CRMC DECISION WORKSHEET

2023-04-094

STATE OF RHODE ISLAND
COASTAL RESOURCES MANAGEMENT COUNCIL
STAFF REPORT TO THE COUNCIL

Applicant's Name:	Department of Transportation (State of RI)Department of Transportation
CRMC File Number:	2023-04-094
Project:	Reconstruct "East Bay Bike Path Bridges" over the Barrington and Warren (Palmer) Rivers
Location:	Barrington/Warren East Bay Bike Path Bridges
Water Type/Name:	Type 1, 2, & 3; Barrington & Warren Rivers
Coastal Feature:	Coastal Wetland, Coastal Bluff with Rip Rap
Plans Reviewed:	"East Bay Bike Path Bridge Replacements...Reconstruction Plans Environmental Permitting Set Volume 1"; 28 sheets total; cover dated April 2023 by RIDOT

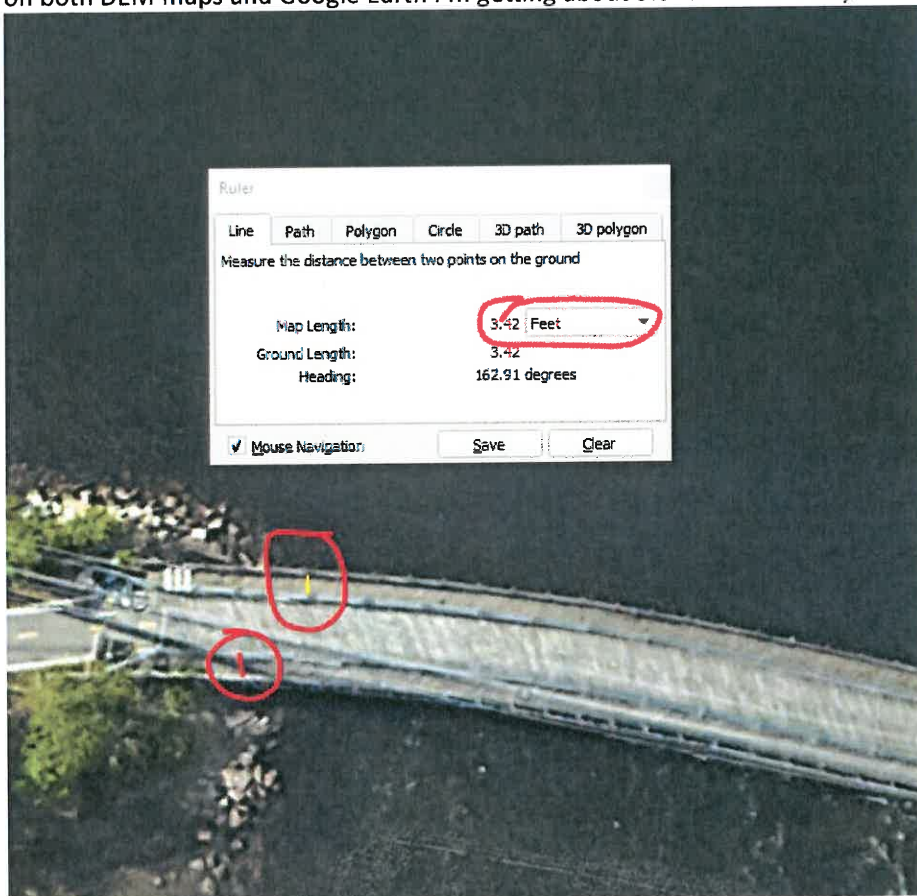
Scott-
Been thinking on this – the bridge wont have grass or split rail fences.
I'm trying to parse if that 2' area will be passable/usable for fishermen.

CRMC is still concerned that once the bridge is constructed, that narrow area will not be passable/usable. The previous bridges had a sidewalk area that I think was wider than 2' that was utilized heavily by fishermen (using the measure tool on both DEM maps and Google Earth I'm getting about 3.5' on either side).

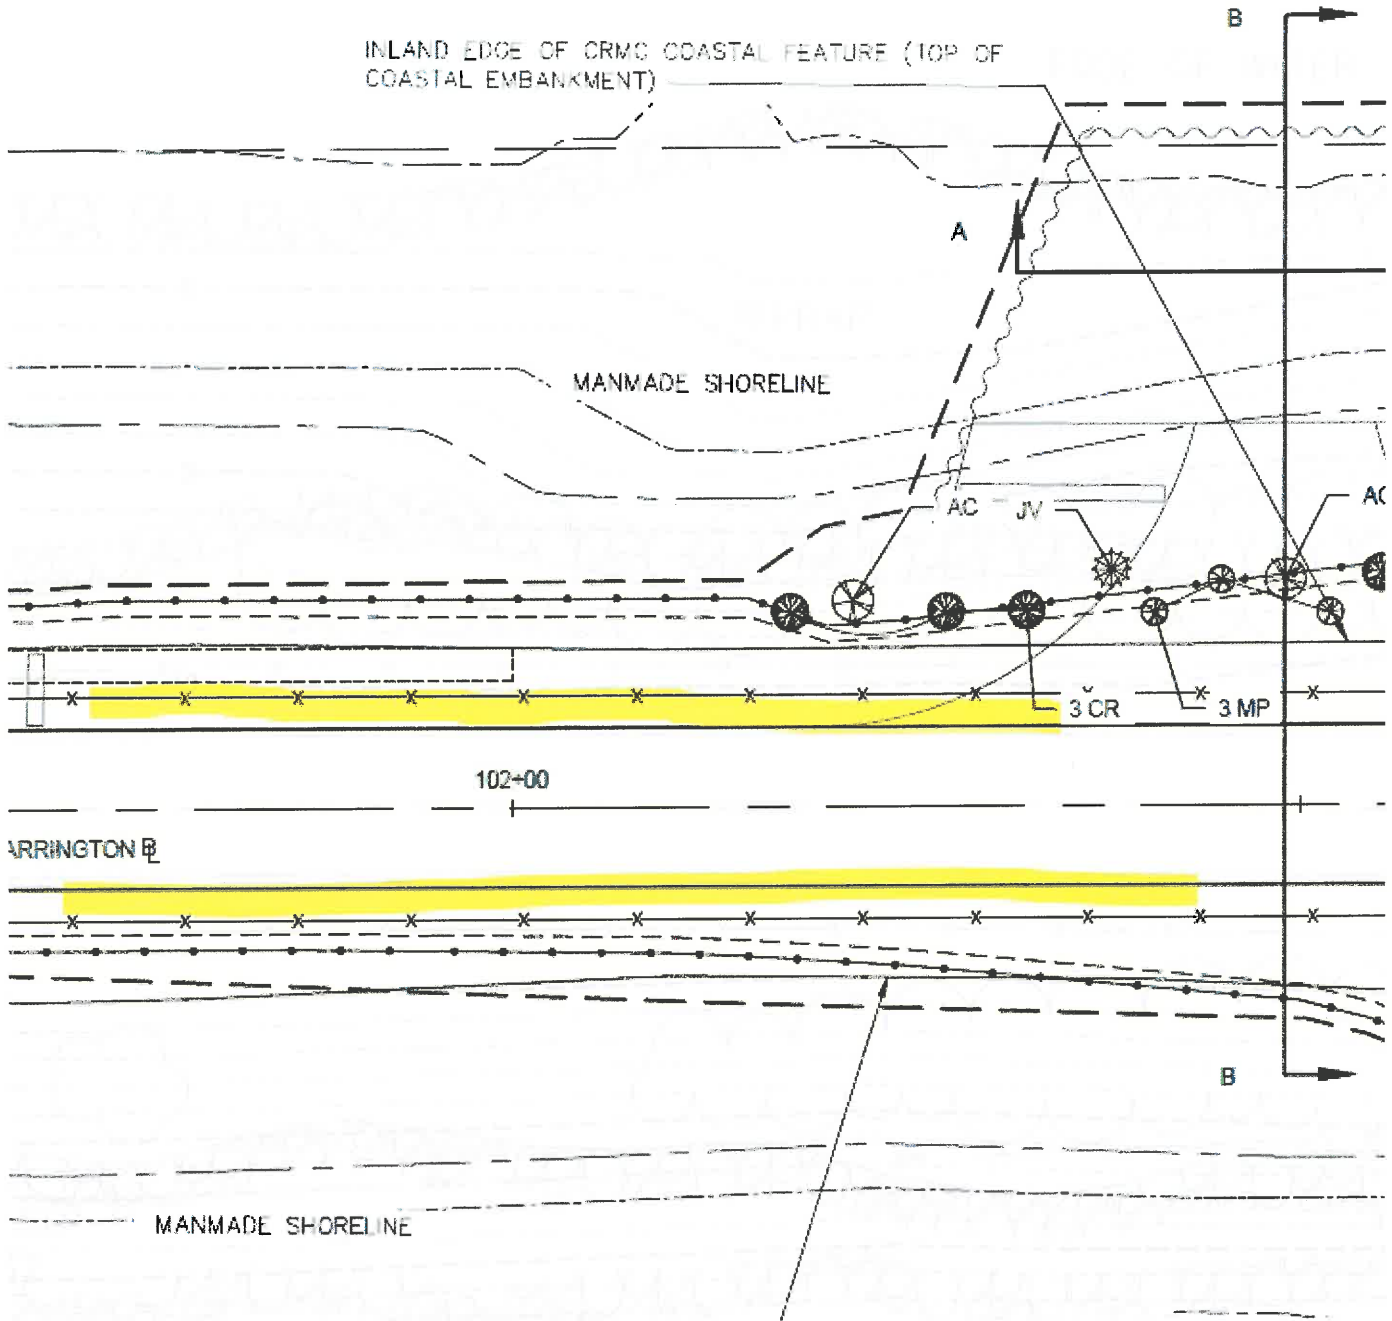
Im working on the report. Can you tell me if the new bridges will have "sidewalks" on either side like the previous bridges did? It looks like maybe they do? I'm seeing a space between the edge of the path and the fencing.

The proposed bridges will not have sidewalks *per se*, but the bridges are 14 feet wide such that their approaches transition into the 10-foot-wide pavement of the Bike Path mainline. The areas you highlight are two-foot-wide grassed shoulders, between the pavement edges and split-rail fences. The new bridges hold the same 14-foot inside width as between the split-rail fences.
